Serial No. 10/064,752

**Amendments to the Drawings**

#### **REMARKS**

Annotated Sheet Showing Changes  
 Appl. No. 10/064,752  
 Amdt. Dated Feb. 15, 2004  
 Reply to Office Act of Nov. 17, 2004

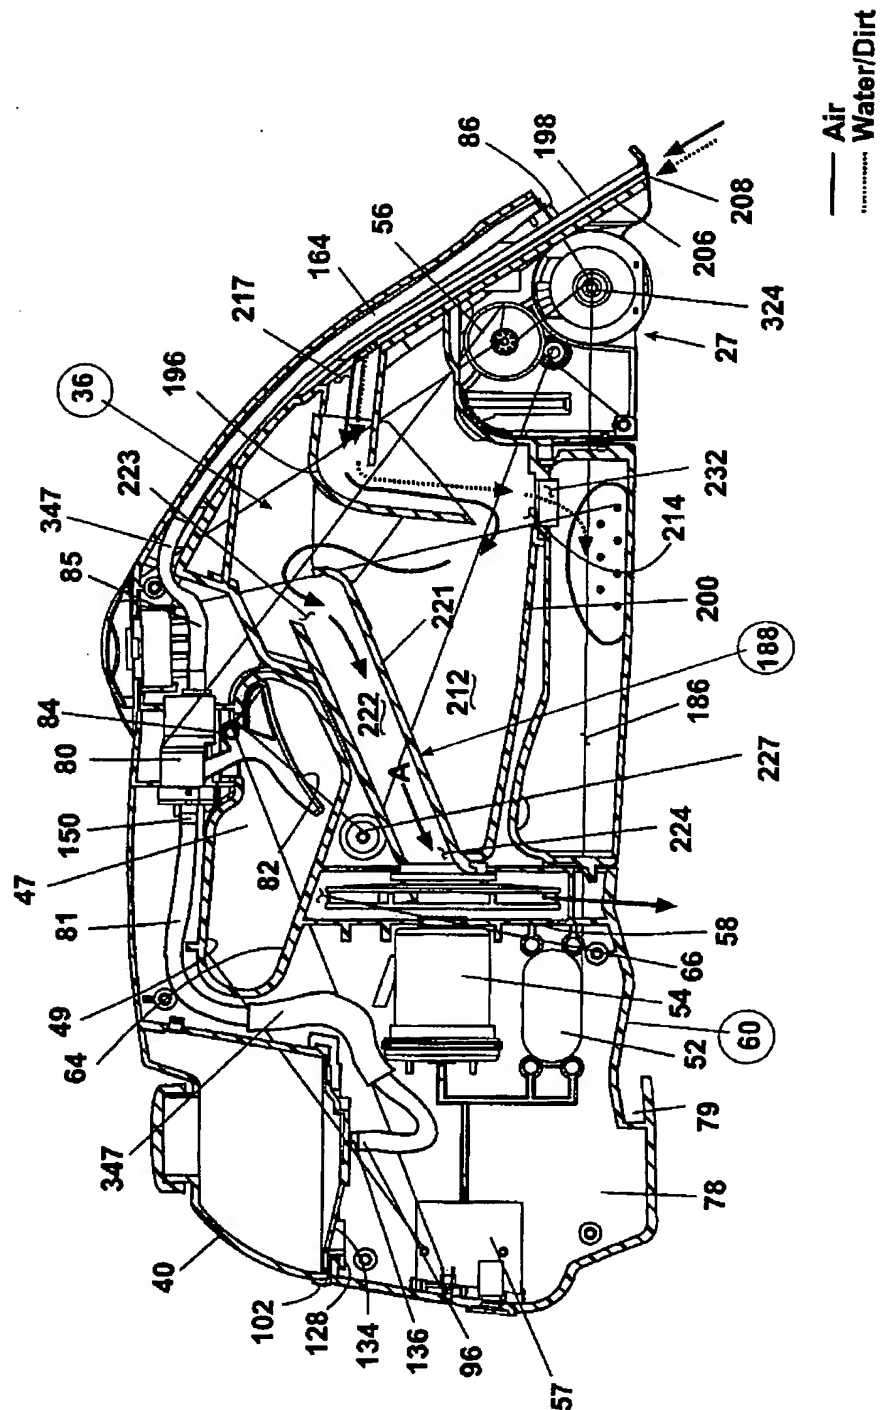
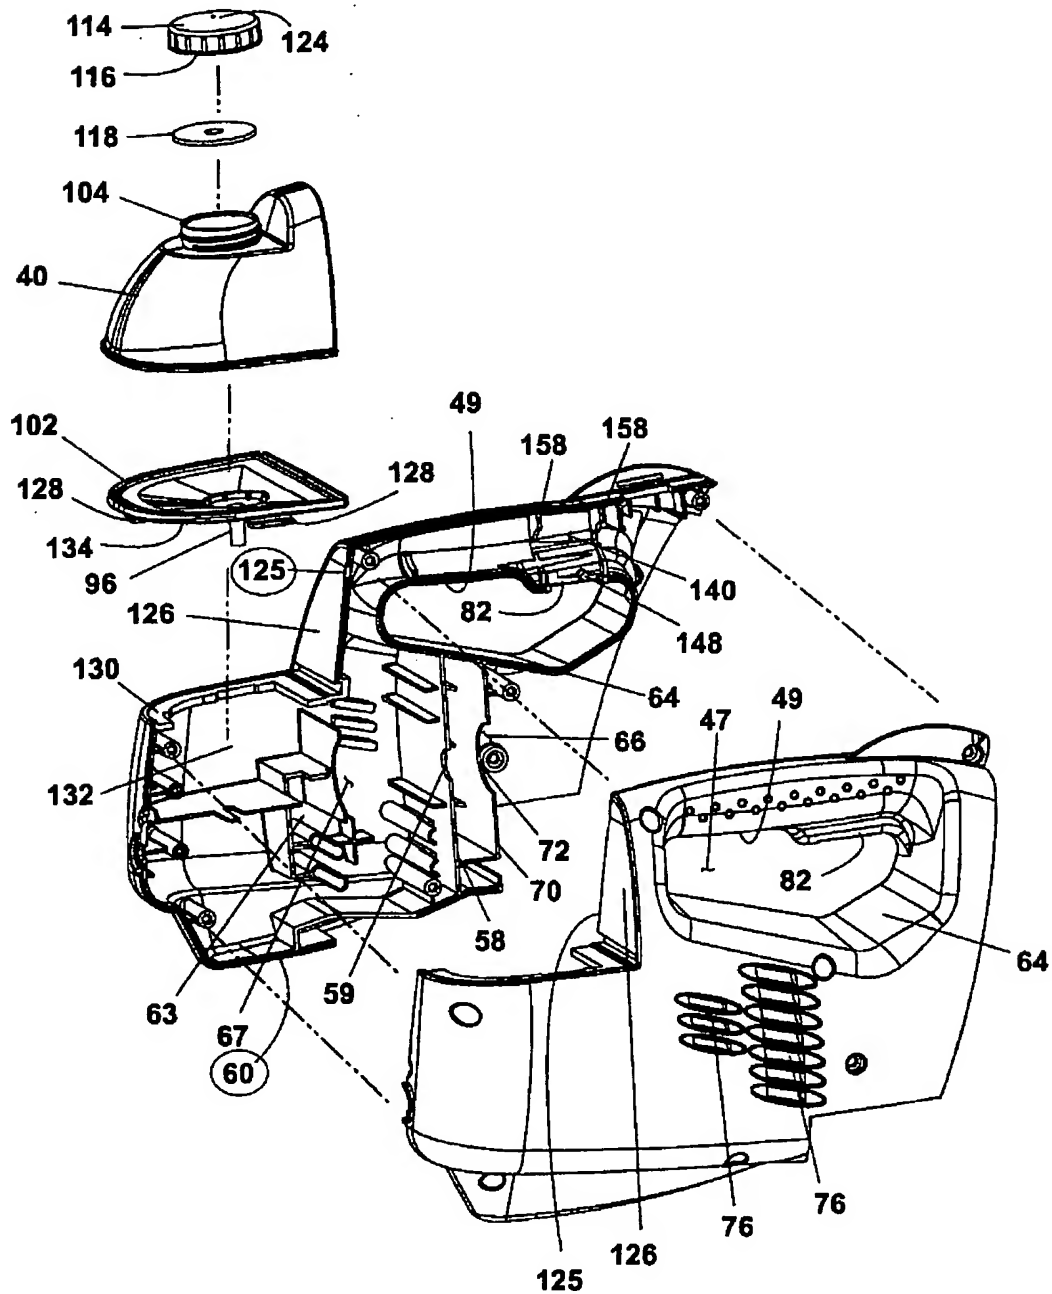
By the present amendment, the specification and drawings have been amended to overcome the objections raised by the Examiner in the Office Action. The Examiner's thorough review of the specification and drawings is appreciated. With respect to the Examiner's objections with respect to numerals 217, 214, 221, and 38 as appearing in paragraph 8 of the Office Action, the numerals 217, 214, and 221 are found in FIG. 3 and number 38 is found in FIG. 2. Further, with respect to the Examiner's objection with respect to page 17, paragraph 92 "through an 314," the passage in the specification reads "through an opening 314".

The attached sheets of drawings include changes to FIGS. 1, 2, 3, 4, 17, and 26. These sheets replace the original sheets including FIGS. 1-4, 17 and 26.
